City of Portland, Maine - Building or Use Permit Application
389 Congress Street, 04101 Tel: (207) 874-8703, Fax: (207) 874-8716

RE: The Shaw Residence
Auburn Pines
Portland, Maine

Field Notes

Project Name: Shaw Residence, 685 Auburn Street, Portland, Maine

ROOF SECTION - CONNECTION (TYP AT BOTH SIDES OF BUILDING)
 1"=1'-0"

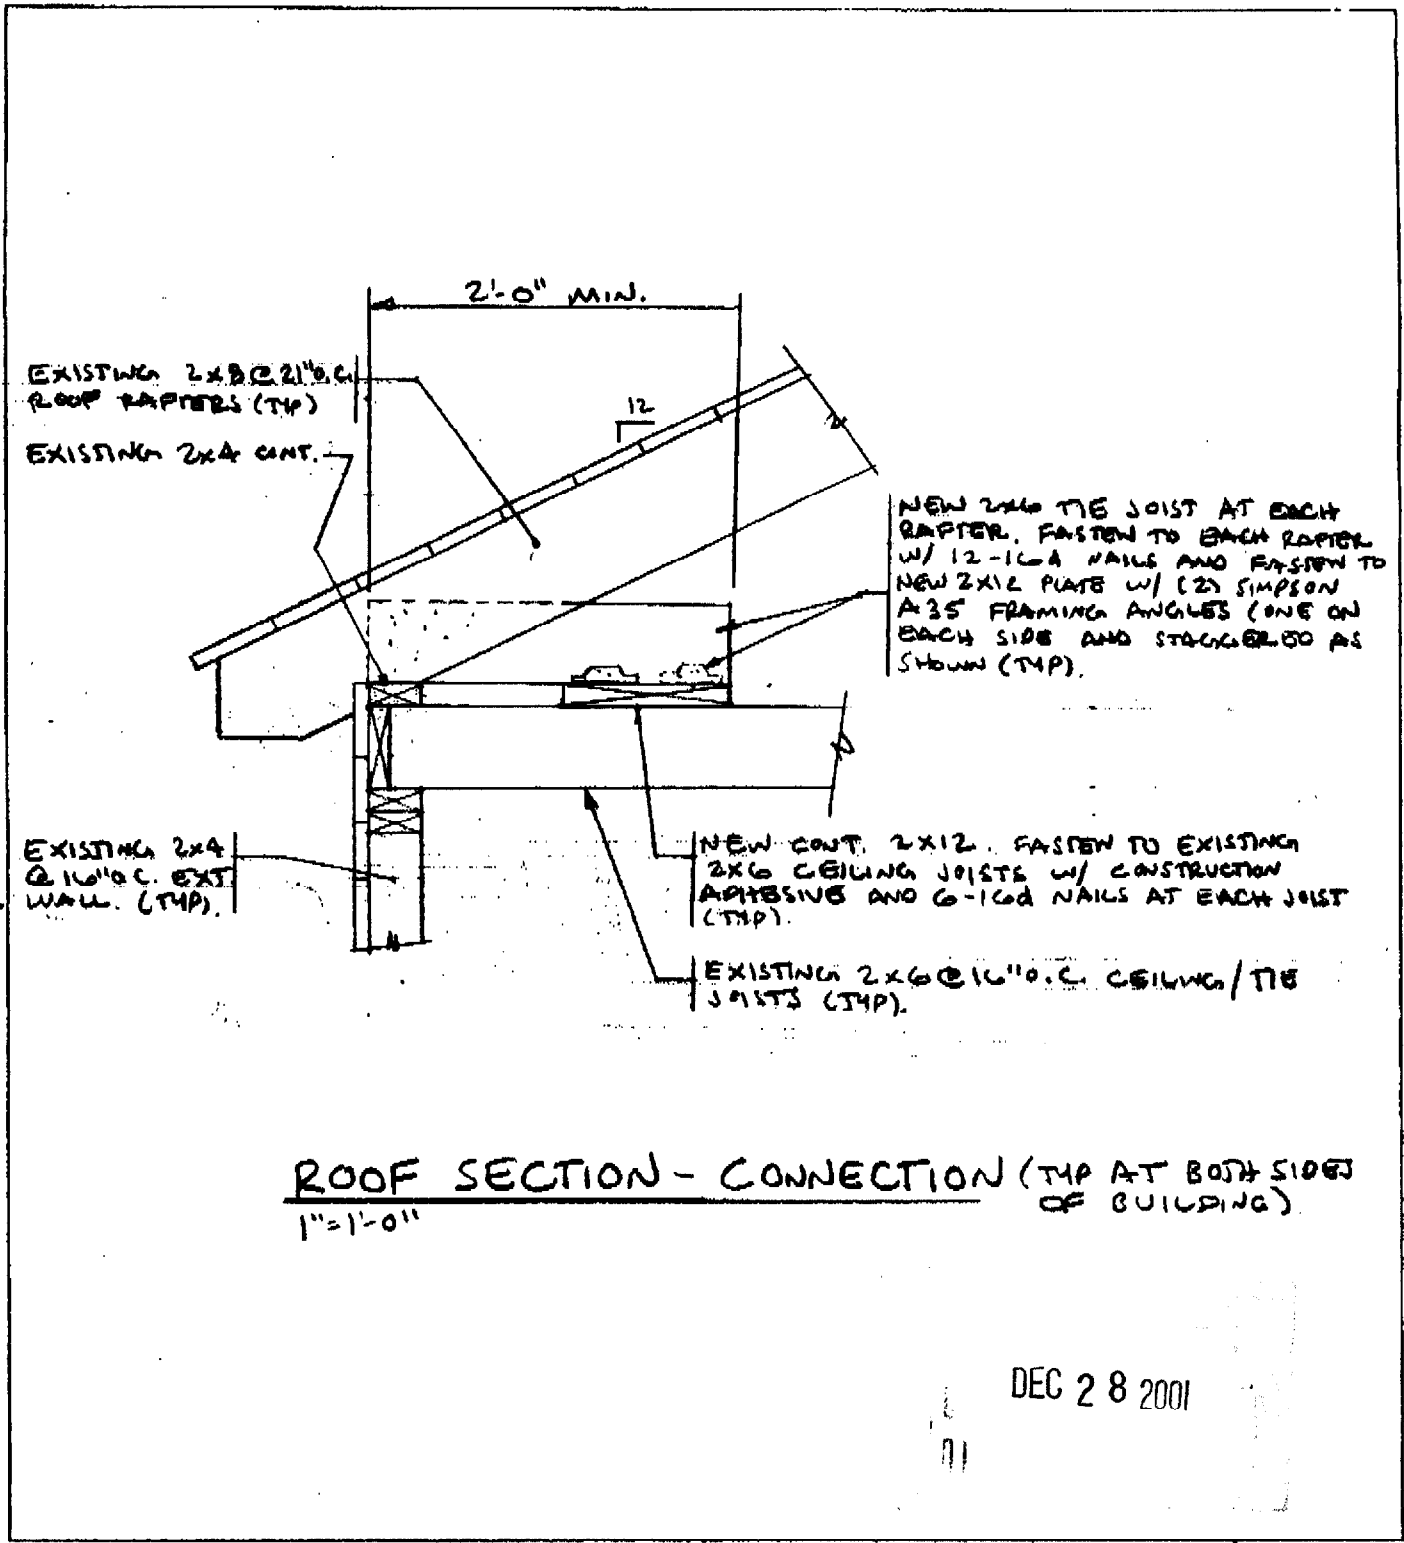
2. There is an inadequate connection of the rafter with the ceiling joists to prevent the roof from "thrusting" the exterior walls outward. We propose the connection illustrated on SKS-1 attached.

designed by:	JHL	SHAW RESIDENCE 685 AUBURN STREET PORTLAND, ME	L & L STRUCTURAL ENGINEERING SERVICES, INC. 80X O STREET SOUTH PORTLAND, MAINE 04106 PHONE: (207) 762-4800 FAX: (207) 762-4801
drawn by:	JHL		
checked by:	MFL		
scale:	NOTED		
date:	12/19/01		
ROOF SECTION.

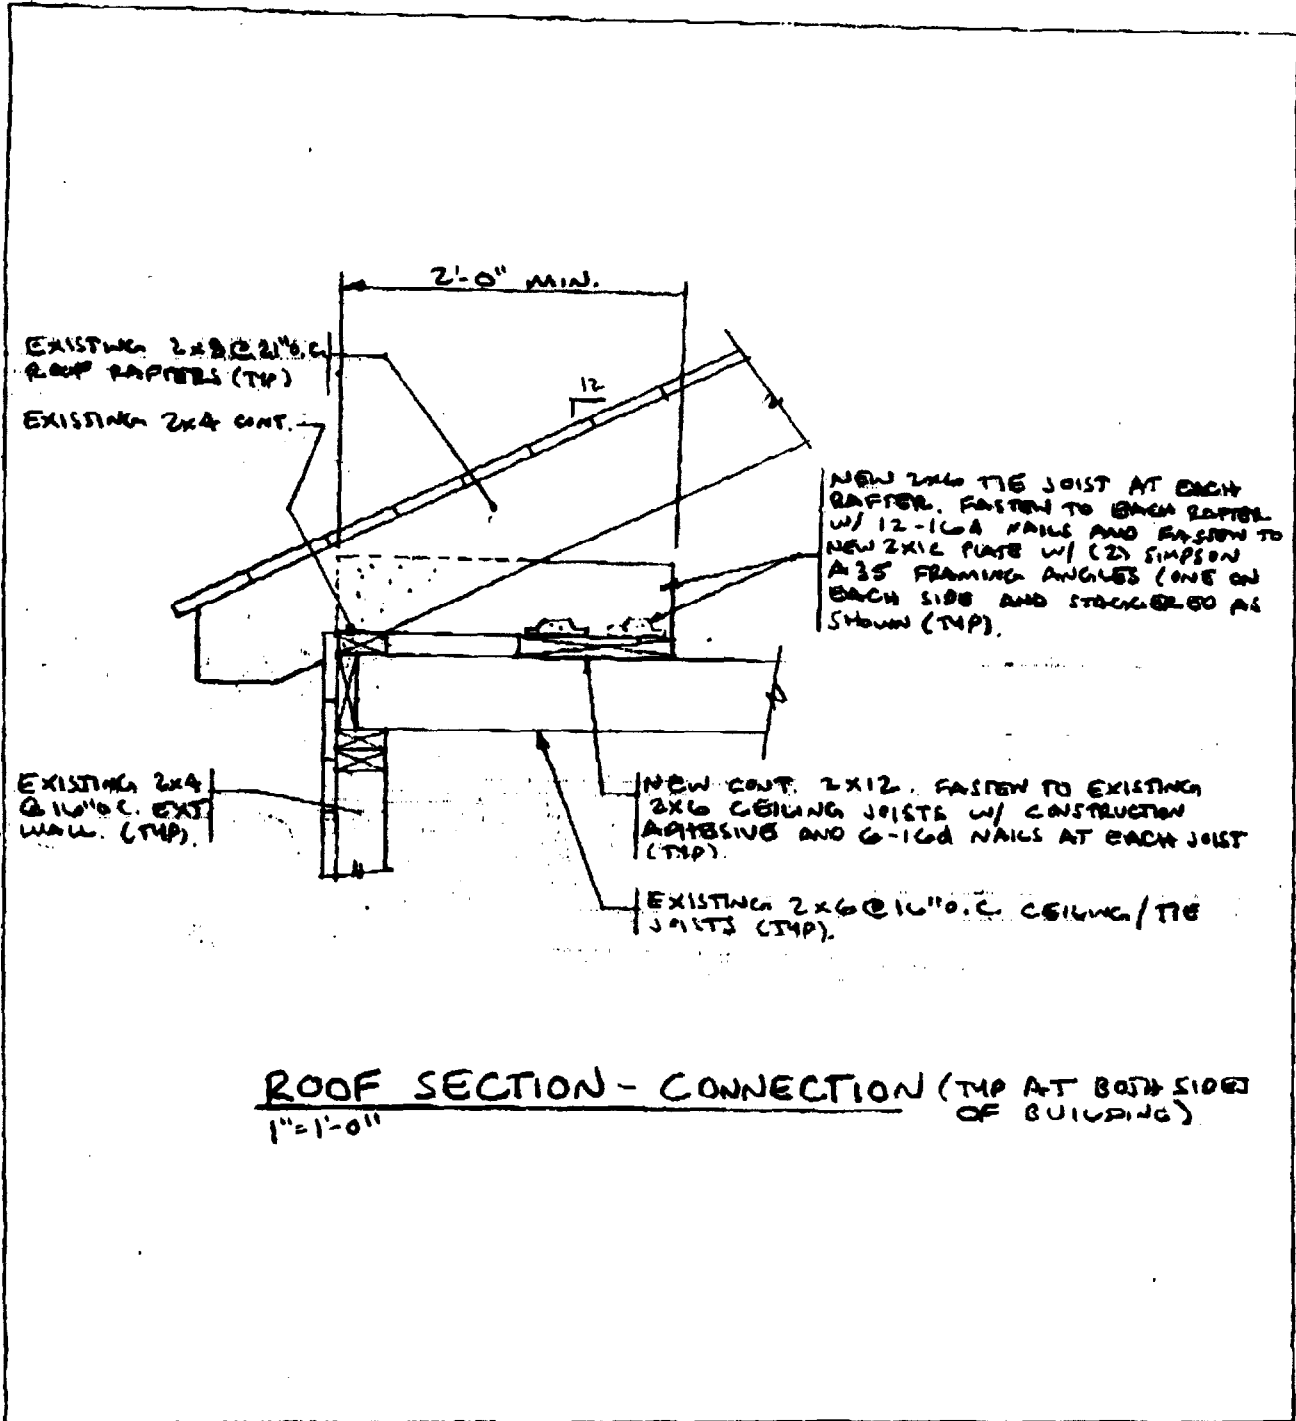
2. There is an inadequate connection of the rafter with the ceiling joists to prevent the roof from "thrusting" the exterior walls outward. We propose the connection illustrated on SKS-1 attached.

ROOF SECTION - CONNECTION (TYP AT BOTH SIDES OF BUILDING)
 1" = 1'-0"

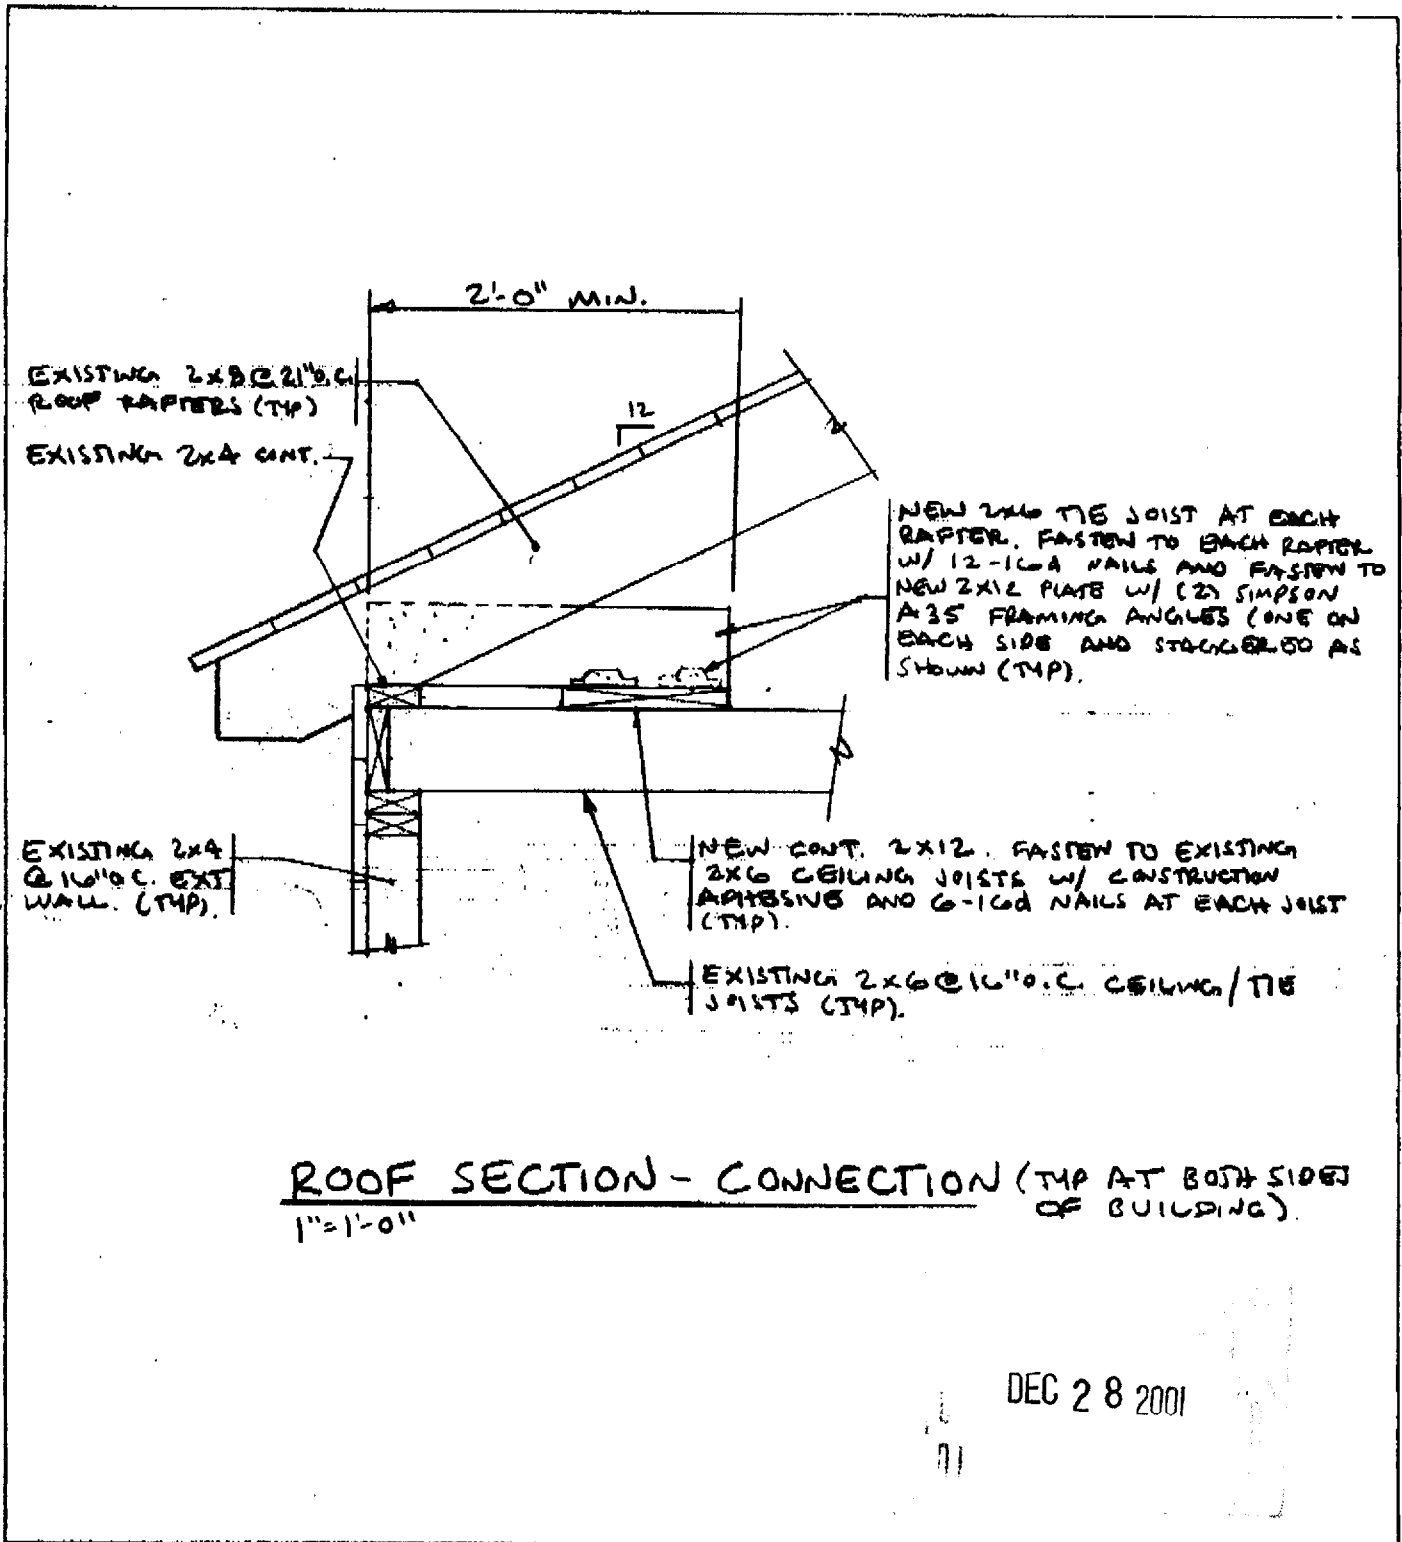
2. There is an inadequate connection of the rafter with the ceiling joists to prevent the roof from "thrusting" the exterior walls outward. We propose the connection illustrated on SKS-1 attached.
